RNTPC Paper No. A/SK-SKT/22B
For Consideration
by the Rural and New Town
Planning Committee
on 20.3.2020

**APPLICATION FOR PERMISSION
UNDER SECTION 16 OF THE TOWN PLANNING ORDINANCE**

APPLICATION NO. A/SK-SKT/22

- restricted to a maximum plot ratio (PR) of 0.75, a maximum site coverage (SC) of 40% and a maximum building height (BH) of 9m (2 storeys over 1 storey of carport)
- Application** : Proposed 19 Houses¹

Drawing Title: MASTER LAYOUT PLAN AND DEVELOPMENT PARAMETERS

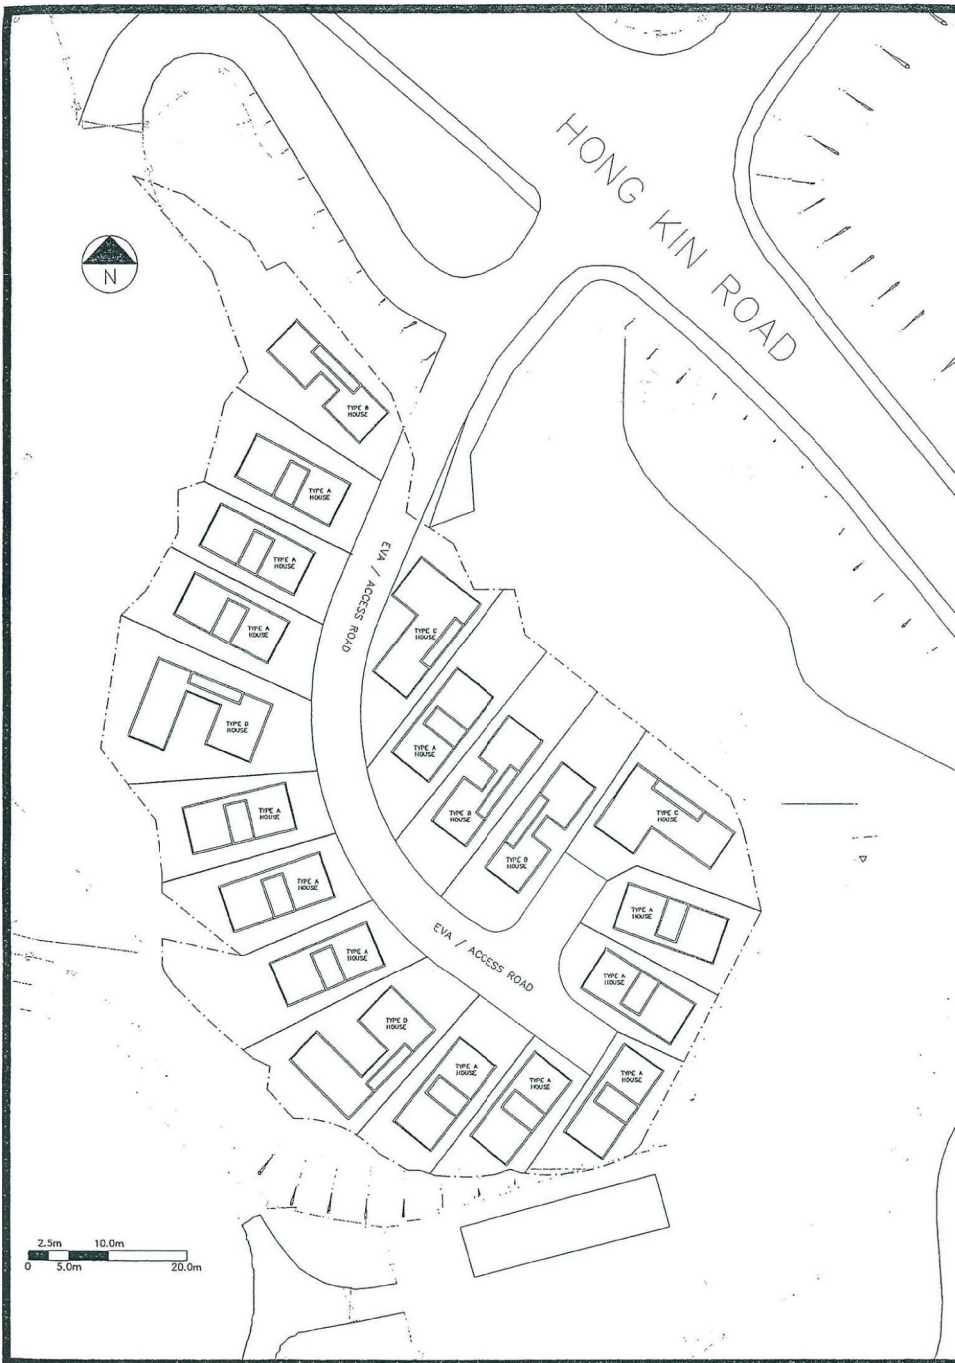
- (b) with reference to Appendix 5 of the submission (**Appendix Ia**), the proposed houses at the western portion of the Site would be in close proximity to an existing operating concrete batching plant. I/R interface problem is anticipated. The applicant is advised to provide relevant mitigation measures, including but not limited to buffer planting along the western boundary of the Site to alleviate the anticipated I/R interface problem, as well as, providing visual buffer between the proposed development and the surrounding natural environment;

- (a) no in-principle objection to the application under the Buildings Ordinance (BO);
- (b) unless the Site abuts on a specified street under Building (Planning) Regulation (B(P)R) 18A (3) of not less than 4.5m wide, its development intensity should be determined by the Building Authority under B(P)R 19(3). In this connection, the applicant should clarify the land status/ integrity of the existing access road connecting the lot to Hong Kin Road;

- (e) Emergency Vehicular Access (EVA) complying with B(P)R 41D shall be provided for all blocks within the Site; and
- (f) detailed comments will be given during general building plans submission stage.

Drawing Title
 HOUSE TYPE A - PLANS, SECTION AND ELEVATIONS

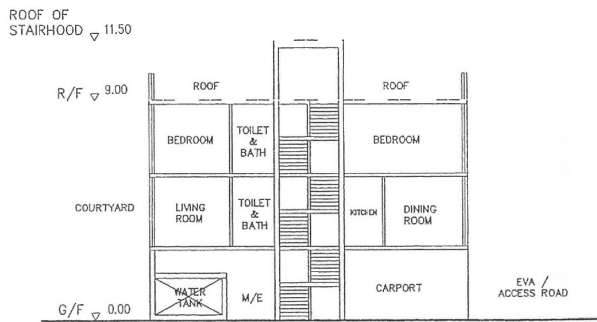
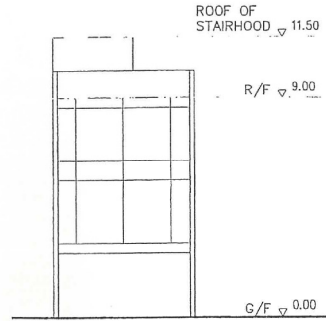
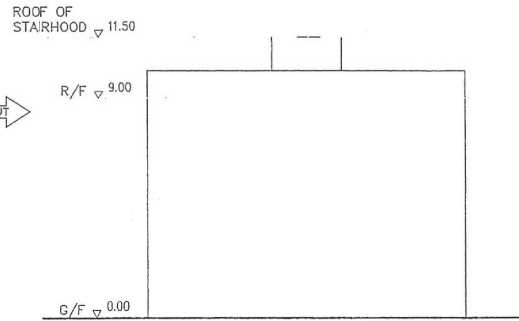
- (b) to note the comments of the Commissioner for Transport (C for T) that parking provision for private developments should comply with the requirement under Hong Kong Planning Standards and Guidelines (HKPSG). The number of parking spaces for Type A and Type B Houses (flat size less than 160m²) do not comply with HKPSG;

圖 PLAN
A-2

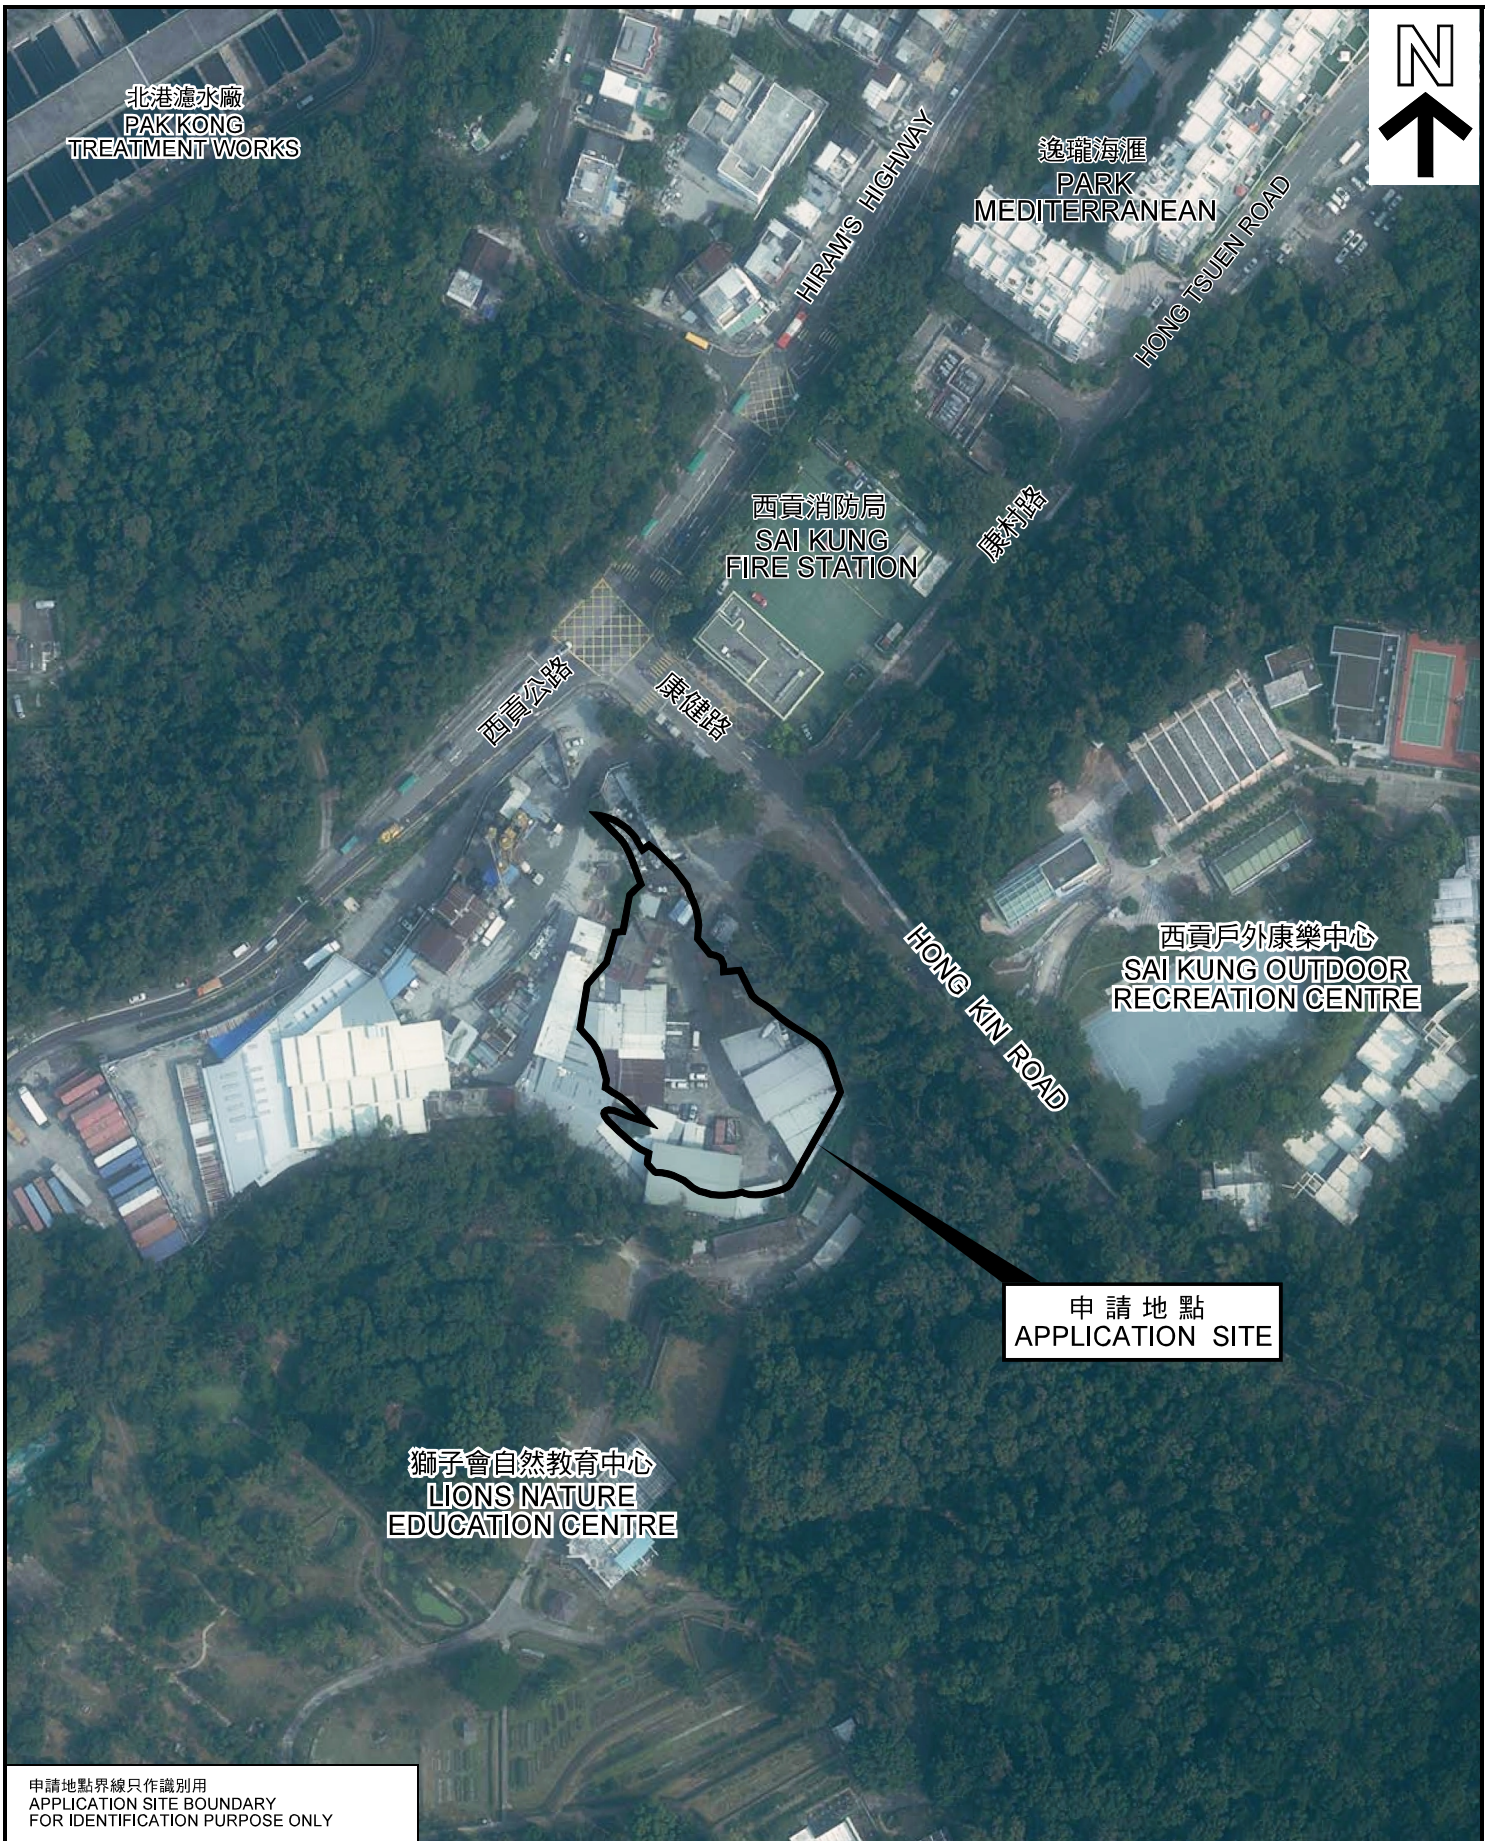
- (a) there is a high pressure town gas transmission pipeline (running along Hiram's Highway) in the vicinity of the Site (**Plan A-2**). It is anticipated that the proposed development site will result in a significant increase in population in the vicinity of the above gas installation. A risk assessment would be required from the project proponent to assess the potential risks associated with the gas installation, having considered the proposed development. He agrees to impose an approval condition on the submission of risk assessment;

- 10.2 The Site is in close proximity to existing industrial operations including storage of construction materials, warehouse and concrete batching plant (**Plan A-2**). In particular, the concrete batching plant is about 5m to the north. DLO/SK advises that the concrete batching plant is held under STWs and although there is a mechanism to terminate the waivers, there is no guarantee that such termination notice would be served by the Government to facilitate the proposed development. Hence, it is uncertain as to whether the concrete batching plant will be terminated or relocated in the near future. DEP advises that the proposed residential development would create landuse incompatibility problem with the concrete batching plant. It would cause noise and dust nuisances to future residents. DEP objects to the application in view of the I/R interface issue of the proposed development as dust nuisance arising from I/R interface problem cannot be accounted for in the quantitative AQIA. Regarding the similar case (application No. A/K15/119) mentioned by the applicant, an Environmental Assessment was submitted by the applicant to demonstrate that the proposed development would be environmentally acceptable and the applicant had also committed to provide a number of measures in the building layout design to mitigate the environmental impacts and nuisance from the industrial operations in the vicinity, in which DEP had no objection to the application from environmental perspective. DEP also advises that there is no assessment on noise impact in the revised EA Report to demonstrate the environmental acceptability of the proposed development. Also, there is no assessment on sewerage and drainage impacts in the submission to demonstrate that the proposed development would not induce adverse sewerage and drainage impacts.
